Equipment affected : Tandem Drogue chute bridle P/N: P2007022810 / P1007022810.

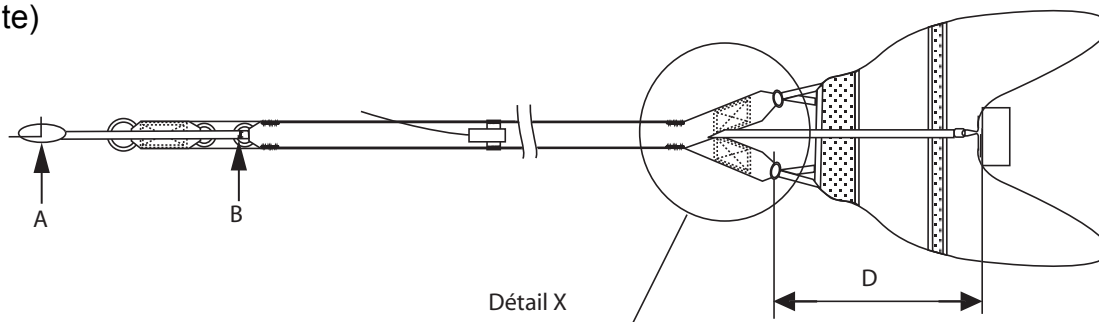
- Strong snatch force after drogue chute assembly release.
- Acceleration of the TANDEM after a drogue chute assembly release due to deployment delay.

- A mix of different generation components.
- Differential ageing of the various subpart materials.

- Hard snatch force effect spreading at beginning of deployment sequence (not enough collapsing of drogue chute).
- A delay during the opening sequence (too much collapsing, poor drag of drogue chute).

- 1- Anchor the lower end of the deflating inner bridle at the point **A**.
- 2- Pull the external white bridle to reach the stop at point **B**, (maximum collapsing of drogue chute)

- 3- Measure the length « **D** » as indicated on the drawing above.

WARNING : Whatever the configuration of drogue chute + drogue chute bridle assembly, the measurement of the dimension starts from the end of external bridle to the handle base.

CORRECT CONFIGURATION : $D = 27 \text{ cm} \pm 5 \text{ cm}$.

- Adjustment of the Bartack sewings location (unpick & re-stitch).
- Adjustment of the inner bridle (too long bridle: unpick & adjust the ending loop of inner bridle on drogue chute side).
- Replacement of the internal bridle (too short bridle). In that case, please contact Parachutes de France After Sales Service.

Detail X

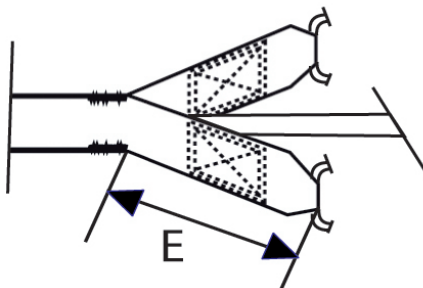
- 4- Check the length « **E** » from the Bartack sewings to the top of the bridle.

$E = 28 \text{ cm} \pm 1.5 \text{ cm}$.
